January 20, 2016

RE: Port of Vancouver Comment Letter on the Tesoro Savage Vancouver Energy Distribution Terminal Facility Draft Environmental Impact Statement

Figure 1. Study Sites

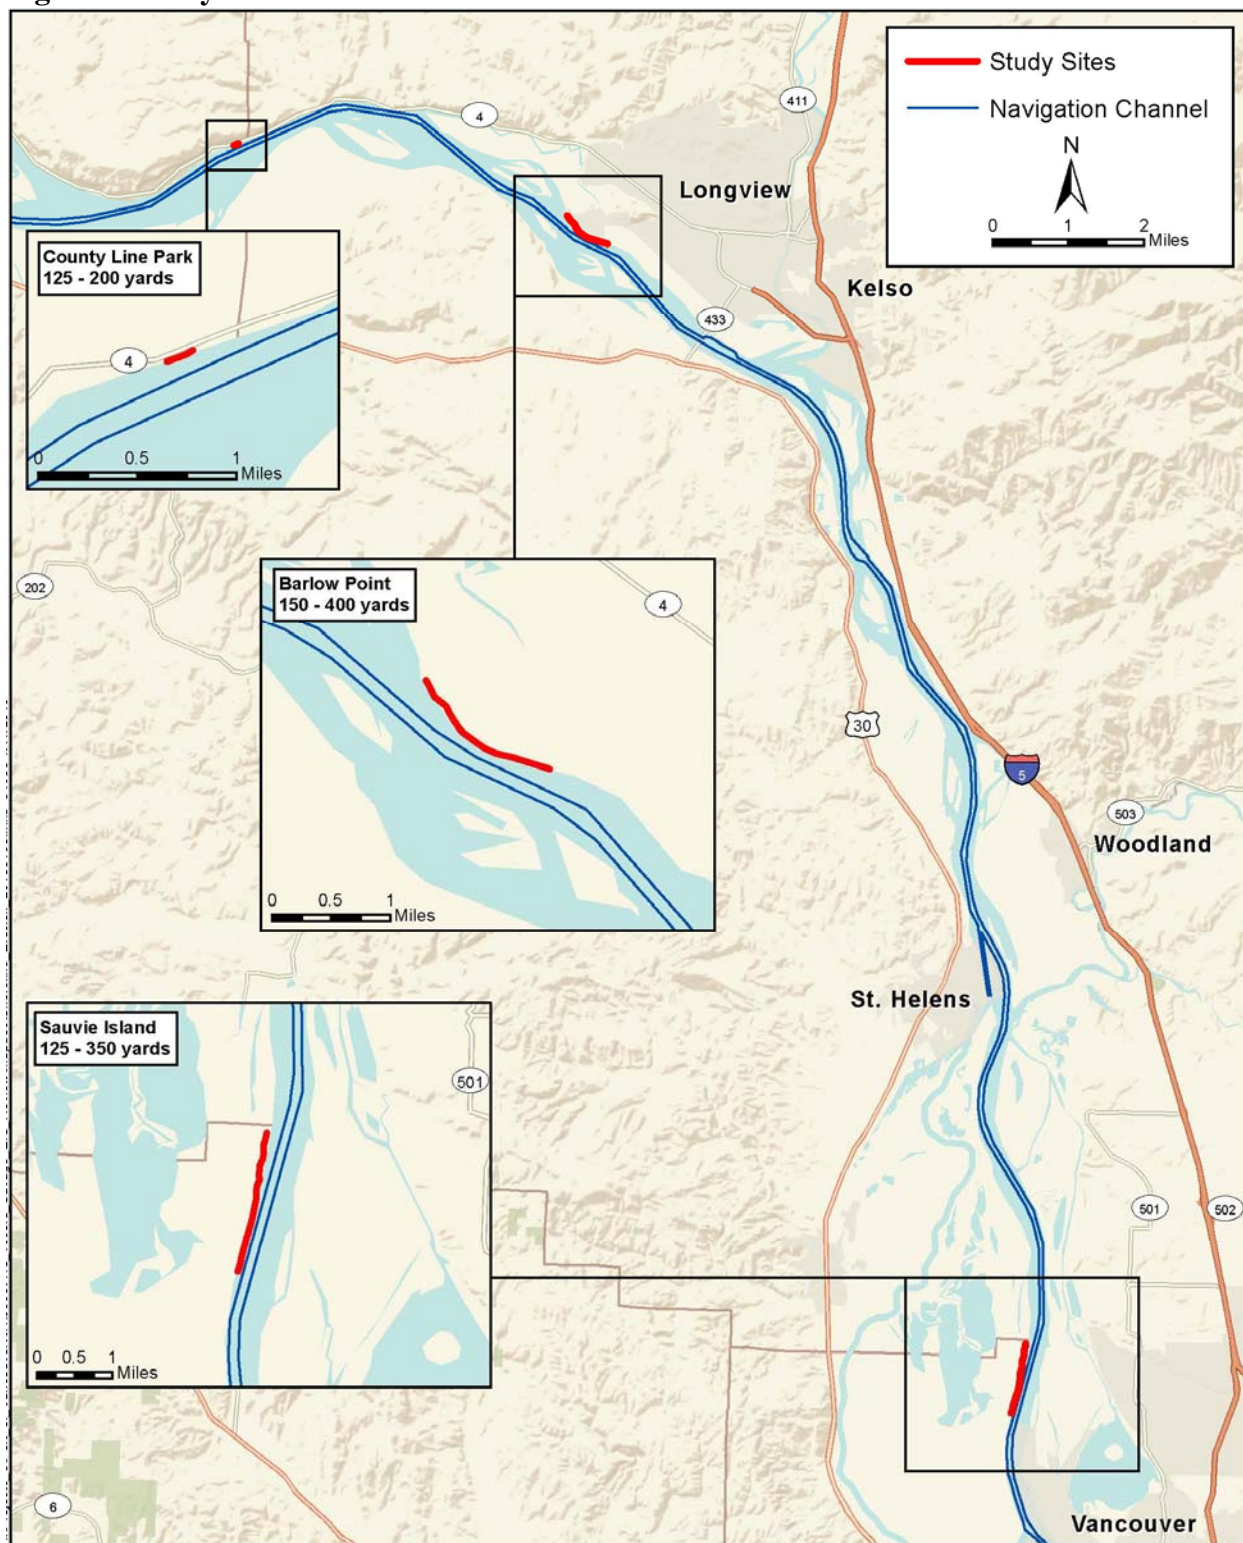
The Draft EIS also speculates that the proposed Project would lead to increases in shoreline erosion in 16% of the lower river where beaches are close to the channel, are not shielded from wave action, and have slopes of less than 10%. Much of the channel is not “close” to the beaches in the lower 33 miles. Measurements in the Pearson and Skalski (2010) study show that two of the three study sites referenced above are 125 to 200 yards from the channel, and the third site, Sauvie Island, is as far as 350 yards from the channel (Figure 1). As shown in Table 3 and in Figure 2, in the lower 35 miles of the Columbia River, the navigation channel ranges from 0.1 to 5.4 miles from the shoreline. By stating that vessel wake impacts would be greatest in areas where the navigation channel is close to the shoreline, the Draft EIS continues to oversimplify the factors that influence wake dynamics and overstates the potential impacts related to the Proposed Action.

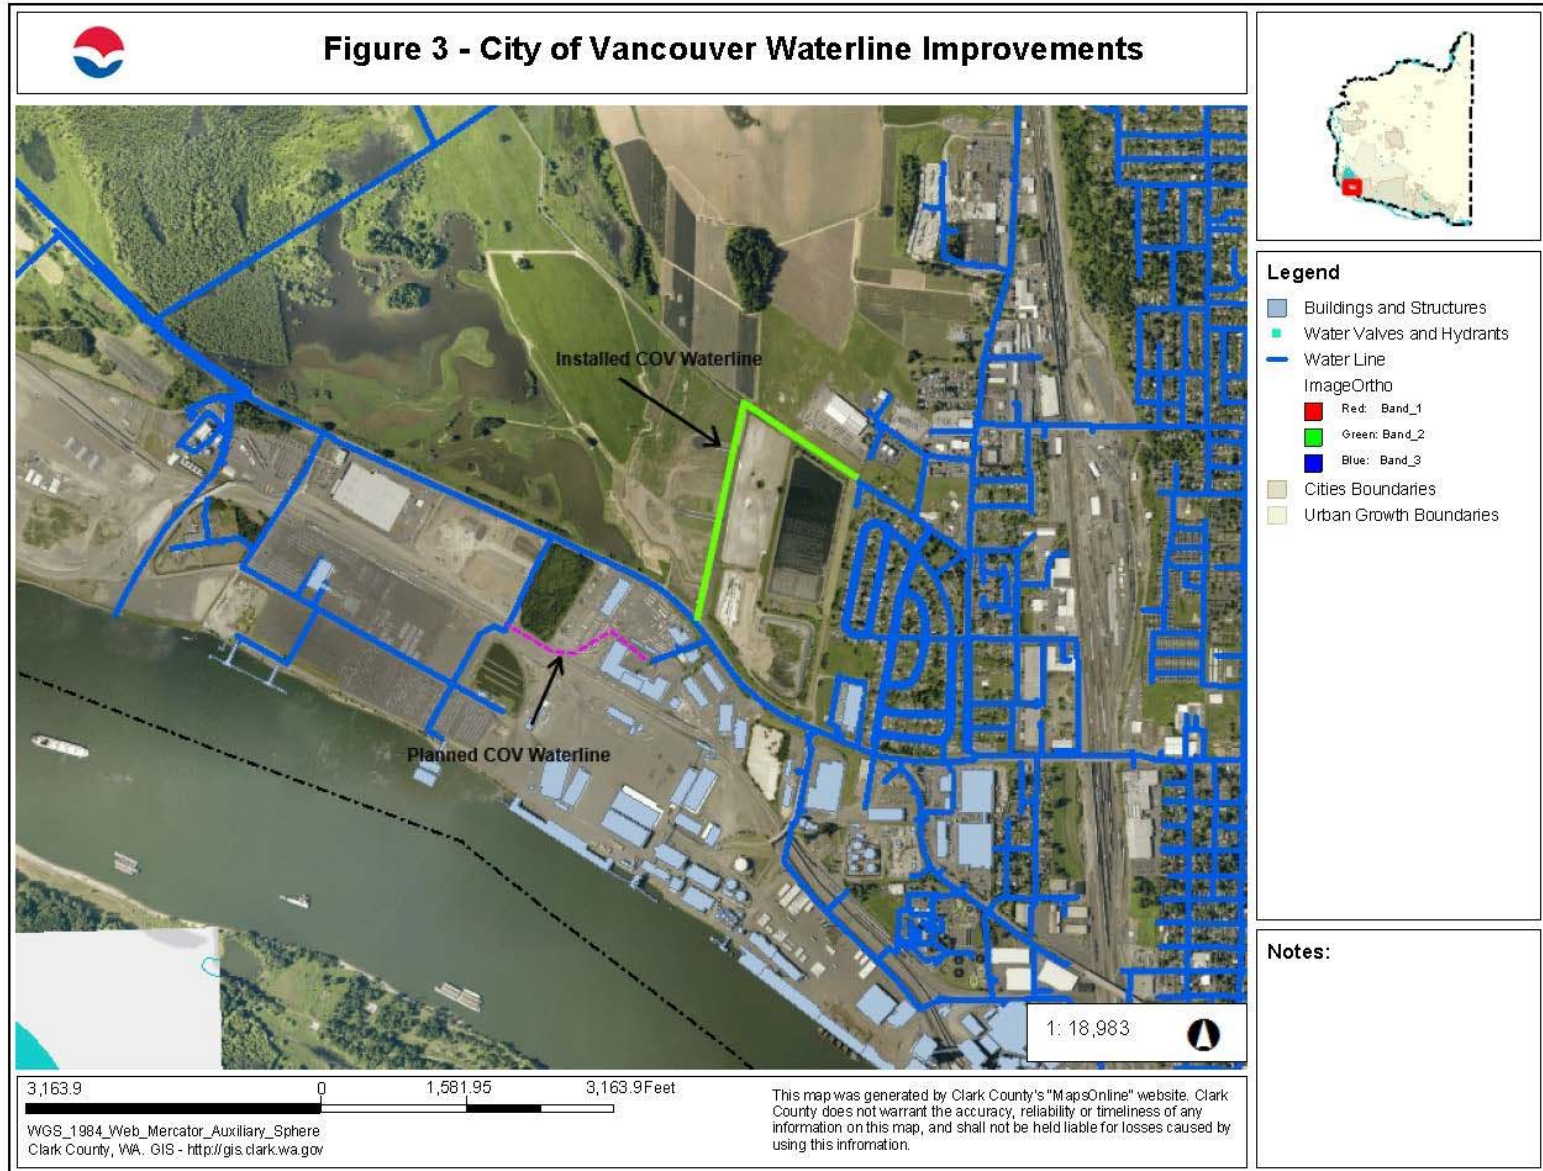
Chapter/Section	Page #	Comment
Chapter 5, Cumulative Impacts	5-30	Section 5.7.2, Aquatic Resources, Rail Transportation, first sentence, is inaccurate. The railroad ties have been upgraded on these segments with materials that do not contain creosote; therefore, creosote discharge from railroad ties is not likely. The Draft EIS should be updated to reflect this.
Chapter 5, Cumulative Impacts	5-42	Unlike Section 5.16.1, Proposed Facility, and Section 5.16.2, Rail Transportation, Section 5.16.3, Vessel Transportation, does not include a discussion of the potential impacts to emergency service responders.
Appendix B	2-3, 4-1	The report should consider both recent and planned upgrades to the City of Vancouver waterline network to increase reliability of the city's water supply to Terminal 5. The Port plans to construct a parallel 12 inch waterline in the area of the Port administrative offices west toward Area 300 for looped redundancy (Figure 3). The Port anticipates entering into an Intergovernmental Agreement with the city to govern the project specifics which includes a cost-sharing agreement for the work. The Port has included the anticipated costs for its share of the project into its budget forecast for 2017. Additionally, the Port installed a 12 inch waterline (which was dedicated to the city in October 2015) associated with its Centennial Industrial Park. This line connects the city water network between LaFrambois Road and SR-501/Lower River Road and further creates looped redundancy in the area. See Figure 3 – City of Vancouver Waterline Improvements.
